STEP 5 IF YOU HAVE AN "A"-MODEL, REMOVE KEEL TUBE AND BRACKETS. RE-INSTALL BRACKETS ON NEW B-MODEL TYPE KEEL TUBE. (PT# TB-6)

STEP 6 A AND B MODELS

DRAWING # 3

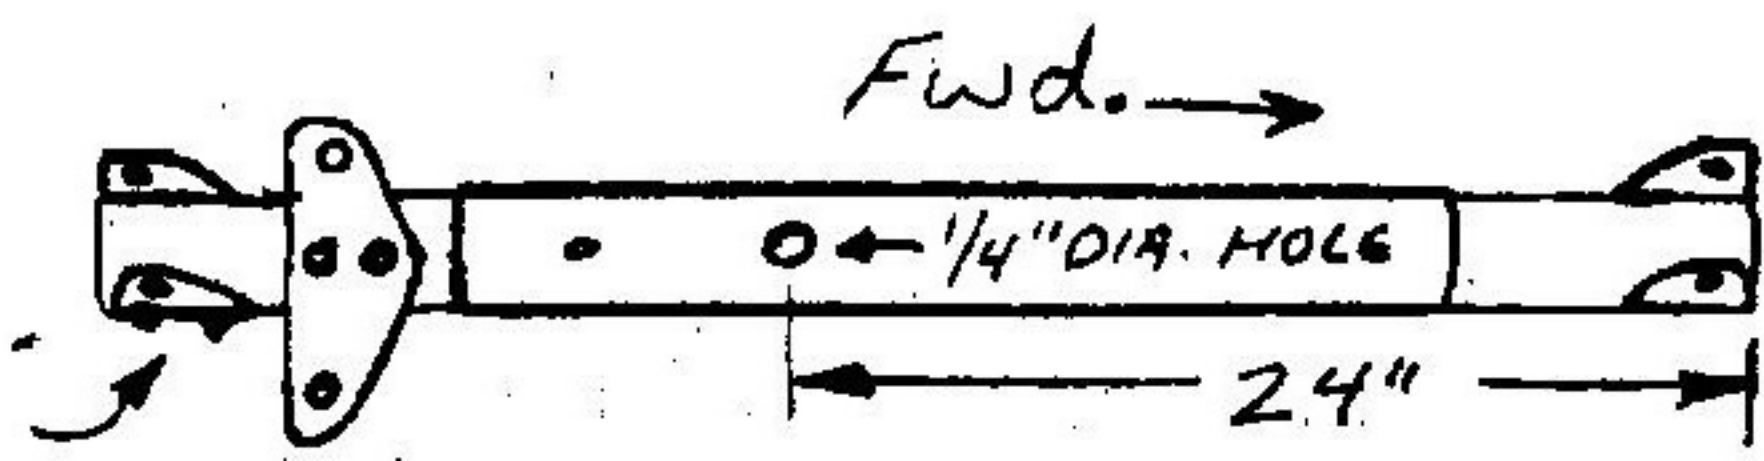
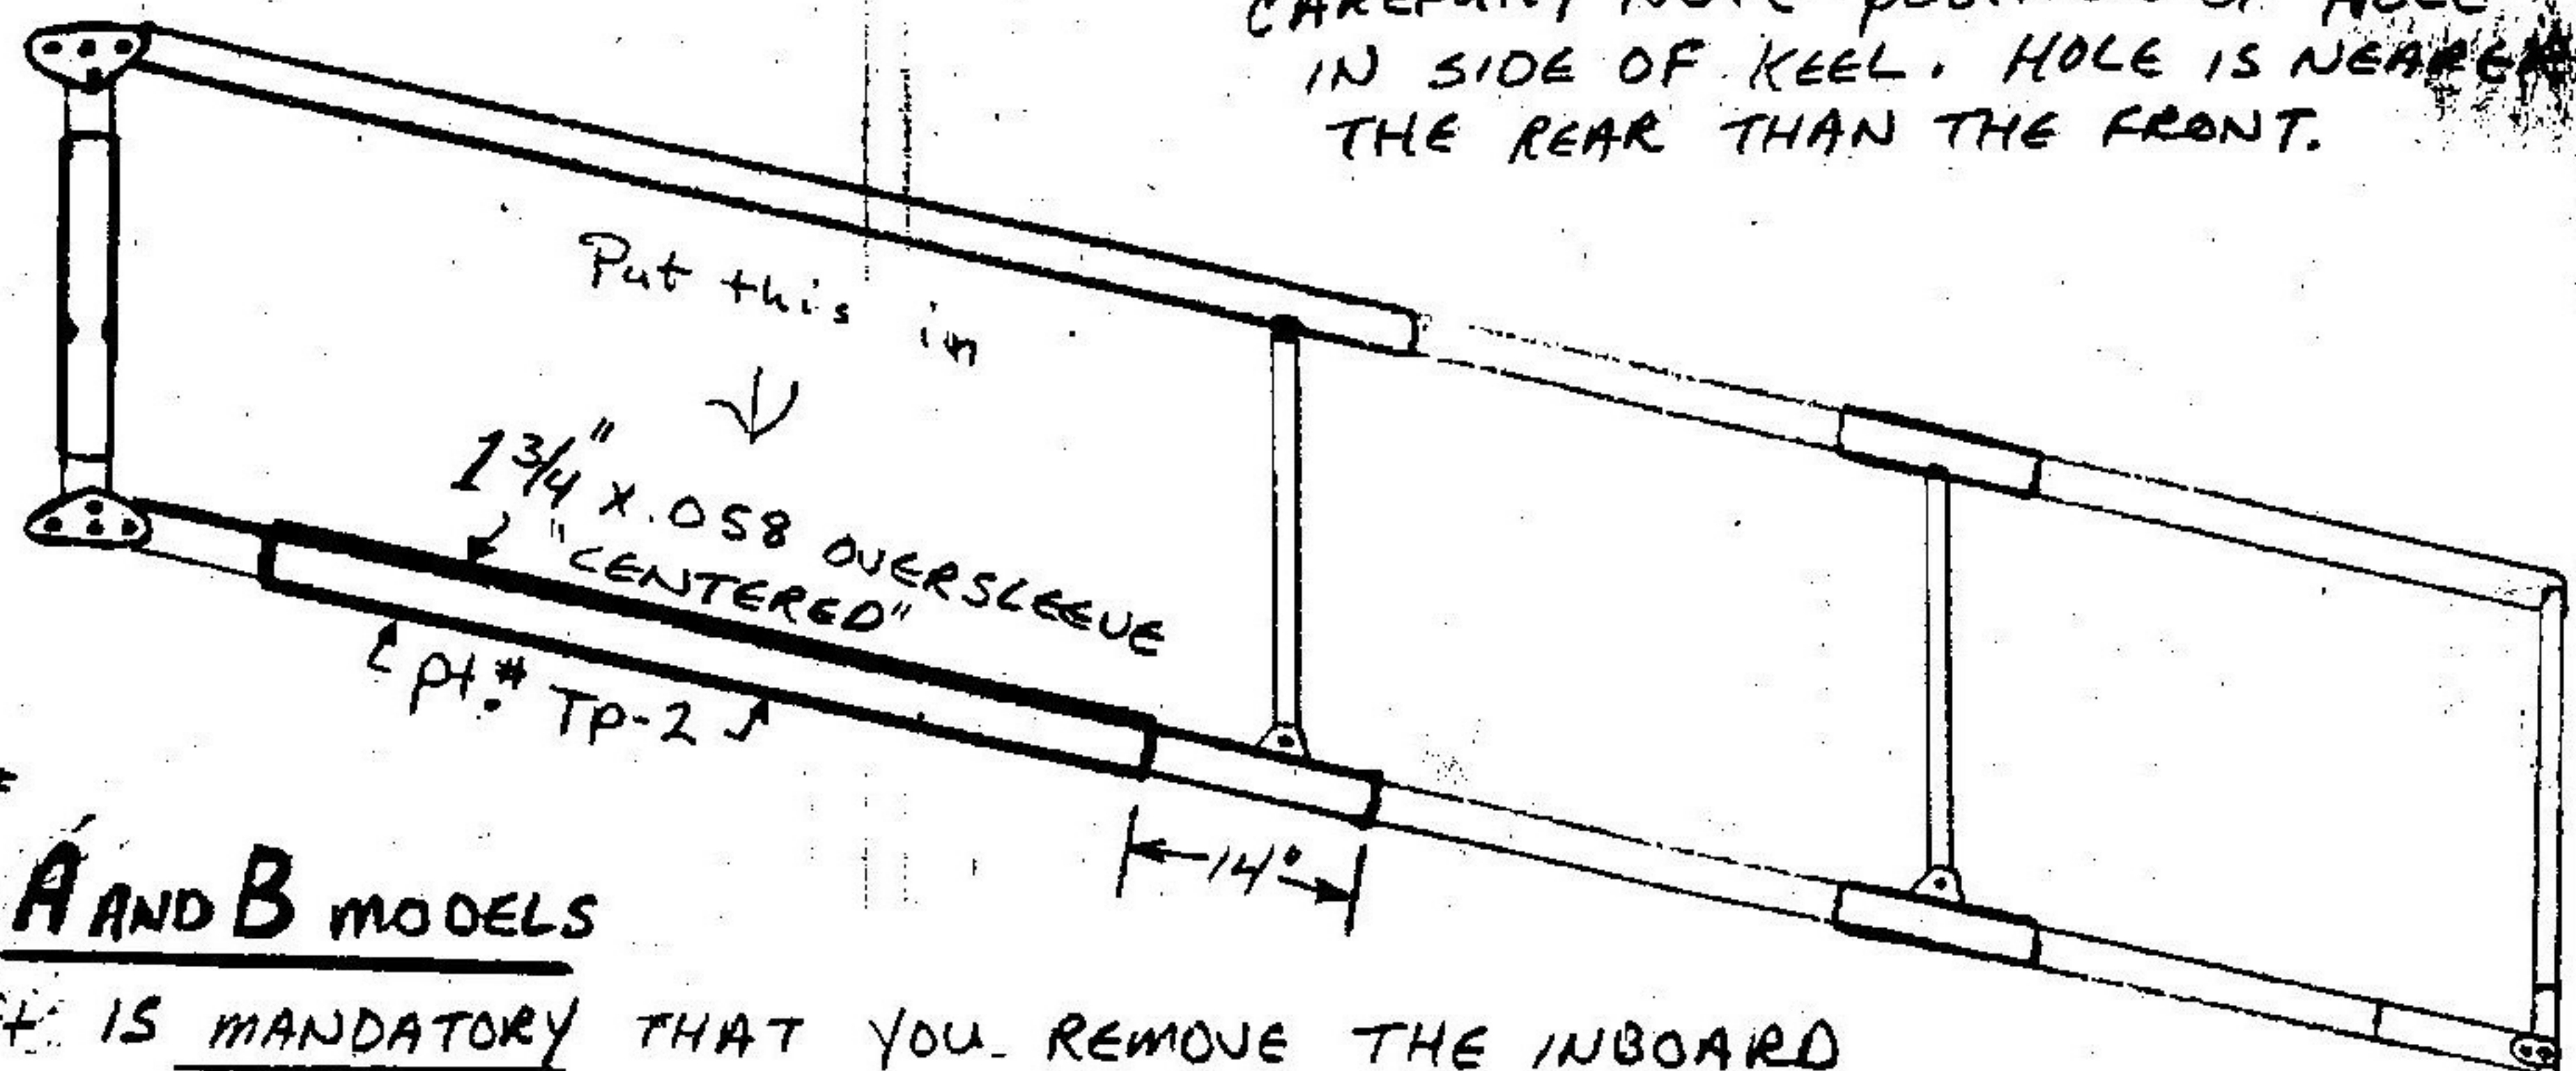
CAREFULLY NOTE POSITION OF HOLE IN SIDE OF KEEL. HOLE IS NEARER THE REAR THAN THE FRONT.

IT IS MANDATORY THAT YOU REMOVE THE INBOARD REAR SPARS FROM THE WING AND INSTALL A 72" LONG x 1 3/4" OVERSLEEVE TO STRENGTHEN EACH WING. SLIDE SLEEVE ON OVER OUTBOARD END OF SPAR AND POSITION AS SHOWN. SECURE IN POSITION WITH TAPE ON ENDS OR I-POP RIVET NEAR ONE END. IT WILL HELP TO SPRAY A LITTLE WD-40 INSIDE SLEEVE PRIOR TO INSTALLATION. RE-ASSEMBLE WING SPARS AND KEEL TUBE AND SECURE WITH PROPER HARDWARE.
